Development Management Sub Committee

**Application for Planning Permission 19/00860/FUL
At 5 Millar Place, Edinburgh, EH10 5HJ
Demolition of existing office premises, and erection of new
office with two flatted dwellings above.**

Item number	4.14
Report number	
Wards	B10 - Morningside

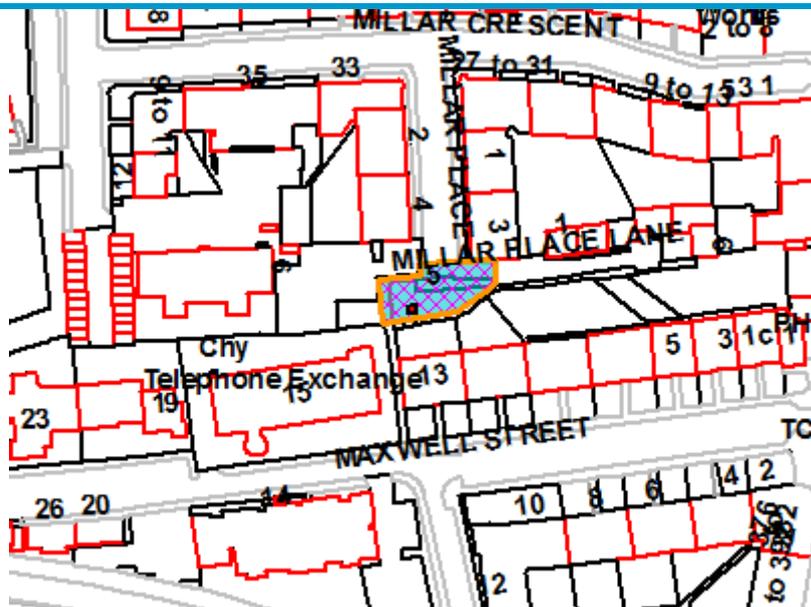
The site overlies part of the original site of the Georgian and Victorian Royal Edinburgh Asylum (for the insane) immediately adjacent to the Female Wing, shown below on a detail taken from the 1876 OS Map.

Accordingly, this site has been identified as occurring within an area of archaeological potential and therefore the application must be considered under the terms Scottish Government's Our Place in Time (OPIT), Scottish Planning Policy (SPP), Historic Environment Scotland's Policy Statement (HESPS) 2016 and Archaeology Strategy and CEC's Edinburgh Local Development Plan (2016) Policy ENV9.

Given the scale of the development it is considered that the potential impact of this proposal would be low, however potentially significant as ground breaking works may disturb significant remains and artifacts associated with this important former hospital. It is recommended therefore that a suitable programme of archaeological work (watching brief) is undertaken during any associated ground breaking-works (demolition and construction) to fully record and excavate any significant archaeological deposits uncovered.

It is recommended that the following condition be attached, if granted, to ensure that this programme of archaeological works is undertaken either prior to or during construction.

'No demolition/development shall take place on the site until the applicant has secured the implementation of a programme of archaeological work (excavation, analysis & reporting,) in accordance with a written scheme of investigation which has been submitted by the applicant and approved by the Planning Authority.'
